## DEVELOPMENT REVIEW COMMITTEE

### 101 S. Ocean Blvd, Pompano Hotel – Site Plan

**Request:** Major Site Plan  
**P&Z Number:** 23-12000042  
**Owner:** Claridge Homes 101 Hotel LP  
**Project Location:** 101 S. Ocean Blvd, Pompano Beach, FL  
**Folio Number:** 494306060690  
**Land Use Designation:** C-Commercial  
**Zoning District:** B-2/AOD (Business District /Atlantic Overlay District)  
**Commission District:** 1 (Andrea McGee)  
**Agent:** Andrew J. Schein (954-617-8919 [aschein@lochrielaw.com](mailto:aschein@lochrielaw.com))  
**Project Planner:** Lauren Gratzner (954-545-7792 [Lauren.Gratzer@copbfl.com](mailto:Lauren.Gratzer@copbfl.com))

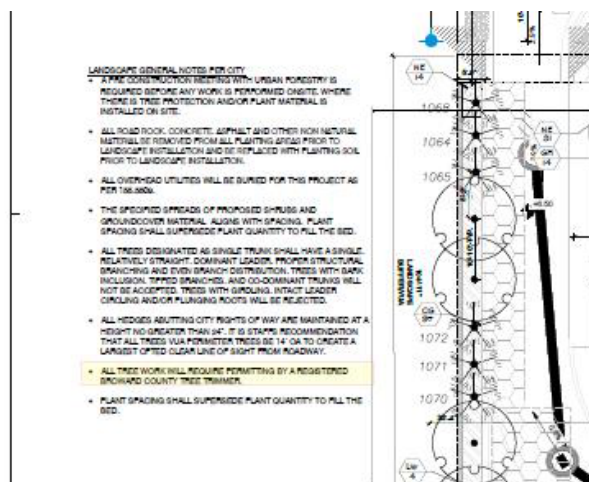
3. Provide a cross section detail of the proposed building footers / slab as it appears that it will encroach into the required foundation landscaping soil space at the footers of the building. Provide drawings and verification of the use of monolithic / eccentric footings as it relates to these areas. AR-004 appears to be on dumpster wall cross sections only.

**RESPONSE:** See detail 2 on sheet AR-004. This will be the typical wall section detail for East, South and North condition at the buildings perimeter. Eccentric footings will be used and strapped back to interior building footings.
